FINAL DRAFT MINUTES

September 19, 2013 Standards Committee Meeting

RE: Minutes from the September 19, 2013 Standards Committee Meeting

802-SCLS-12 SIGN CANTILEVER STRUCTURE DOUBLE ARM AND QUADRI-CHORD BASE PLATE, ANCHOR BOLT, AND METAL SKIRT DETAILS (WITH MARKUPS)

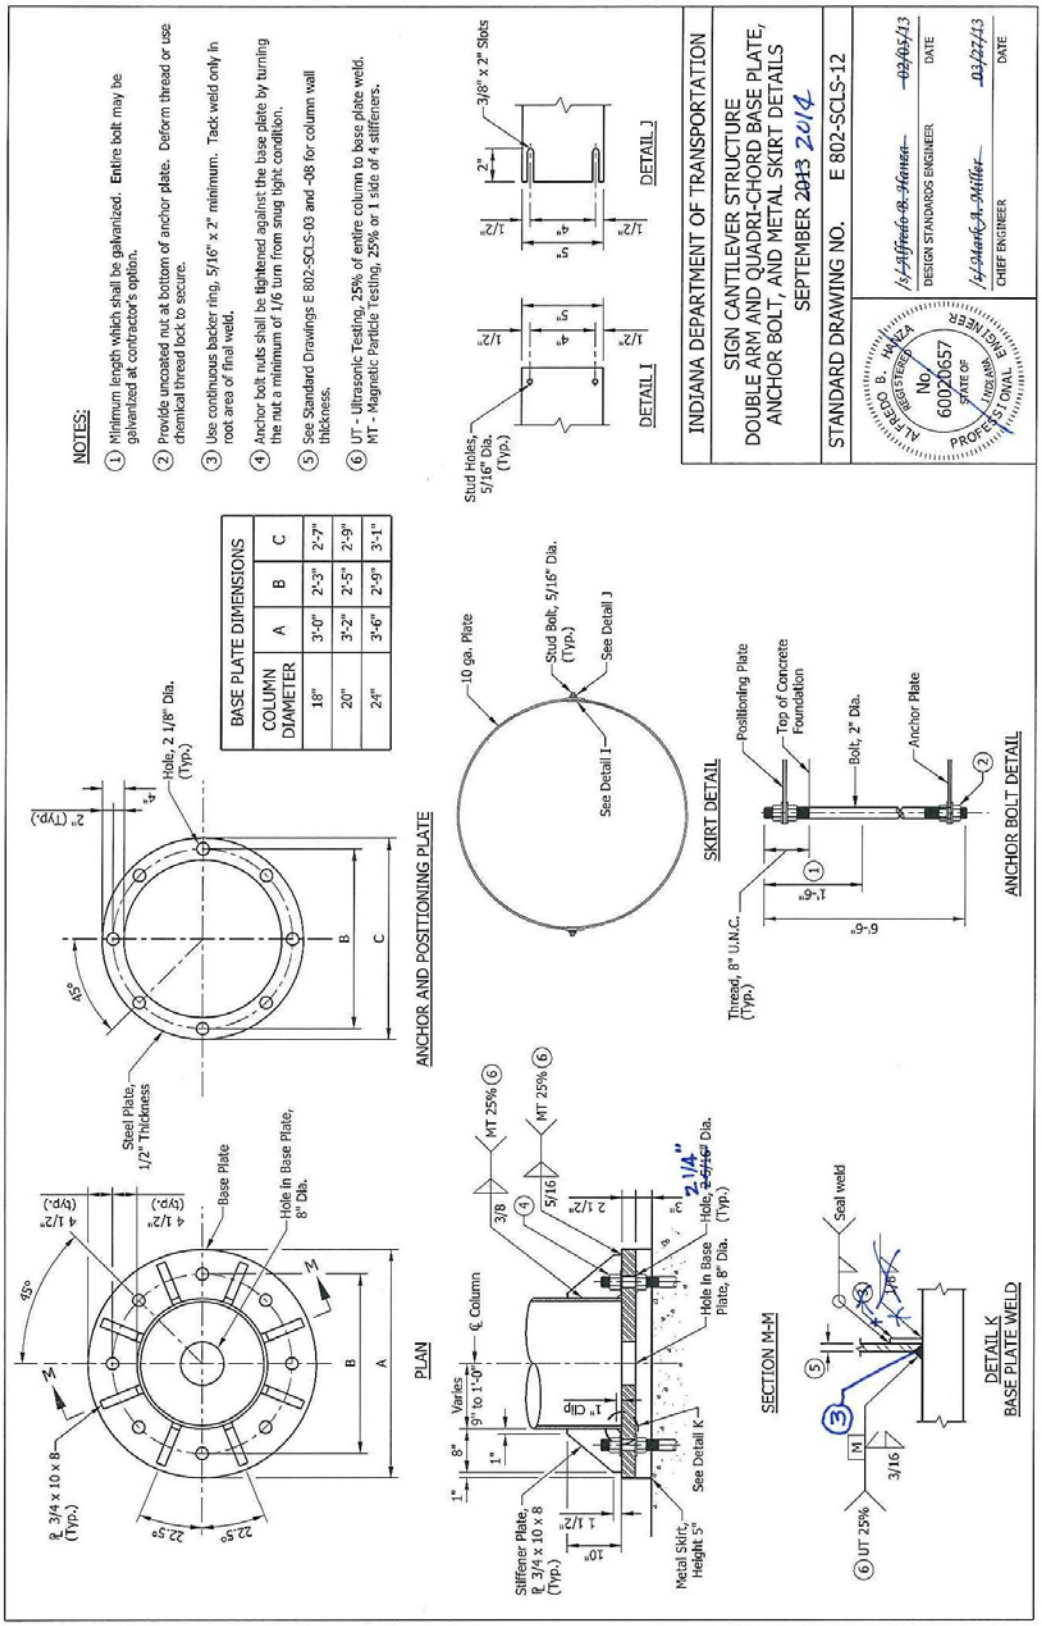
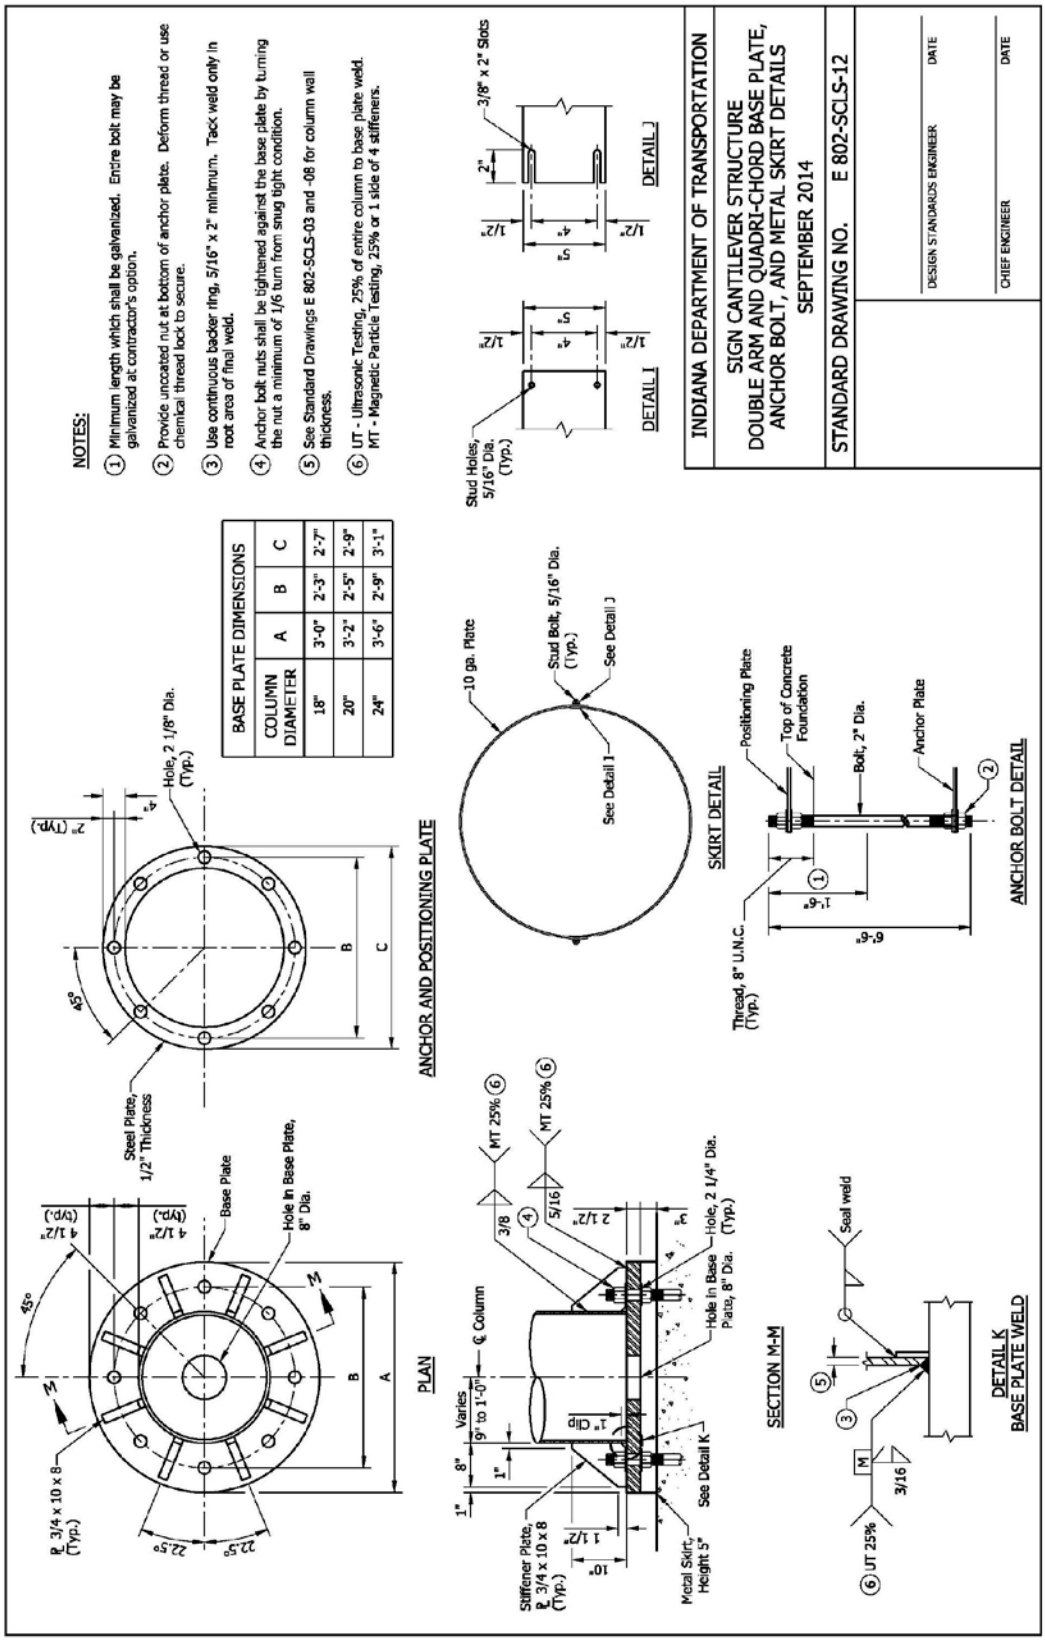
PROBLEM(S) ENCOUNTERED: Sign and signal cantilever structure welding details in certain locations (base plate, arm connection) are not practical to do as shown on current standard drawings. In addition, diameter of base plate hole for anchor bolts in sign cantilever drawing is not consistent with manufacturing practice.

PROPOSED SOLUTION: Revise the welding details (still meeting AASHTO requirements) and change anchor bolt hole diameter from 2 5/16" to 2 1/4" .

DISCUSSION: This item was introduced and presented by Mr. Boruff who expressed the need to revise the shown current standard drawings to reflect current manufacturing practice and AASHTO requirements. These revisions also coincide with previously approved revisions to the last meetings minutes.

Mr. Boruff briefly explained the revisions shown. There was no further discussion and this item was approved as submitted.
